Meeting Notes Project 2007-06 System Protection Coordination Standard Drafting Team

January 6-9, 2014

Based on stakeholder comment, the drafting team made a few revisions to the standard. The changes are all preliminary as the team did not finish reviewing and discussing all of the suggestions received. Please refer to the redline standard attached.

1. **Title:** Protection System Coordination for Performance During Faults
2. **Number:** PRC-027-1
3. **Purpose:** To coordinate Protection Systems for Interconnecting Elements, such that Protection System components operate in the intended sequence during Faults.

Figure 5

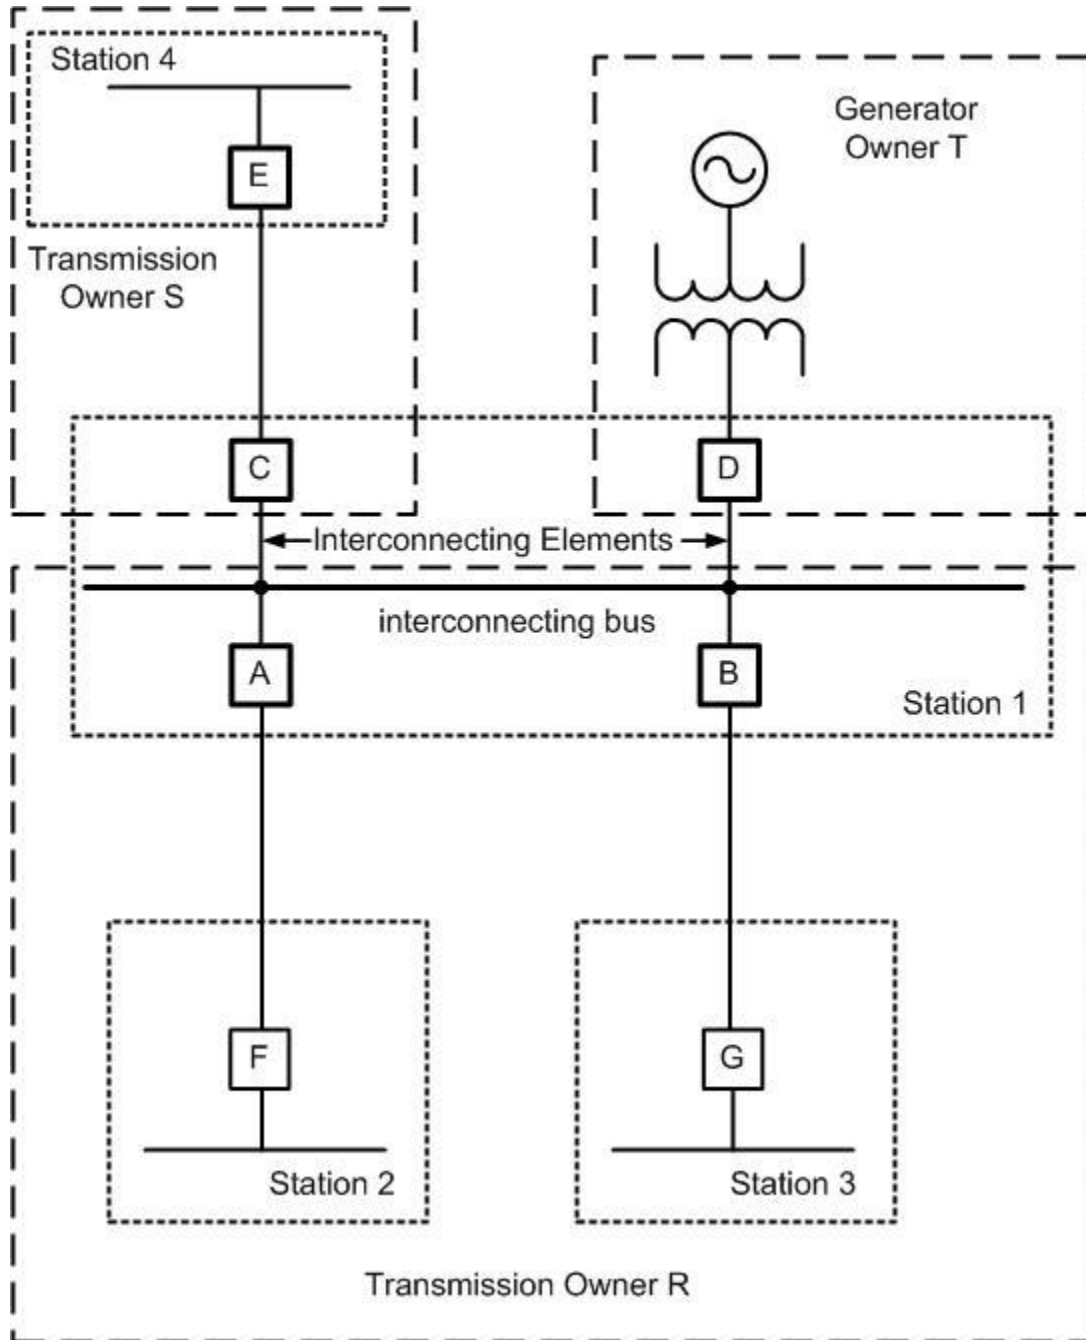
Note: ~~In a large majority of cases, Figure 2 would be applicable for most generator interconnections. In Figure 5 below, Transmission Owner S has no direct Protection Systems located at Station 1 that need to be checked for coordination with Generator Owner T.~~

Figure 5 ~~above~~ illustrates the Interconnecting Elements between the Transmission Owners R and S and Generator Owner T. In this example, Transmission Owner S and Generator Owner T are not directly interconnecting to each other at Station 1. All direct interconnections are between Owner R and each of the other Owners connected to the common bus at Station 1.
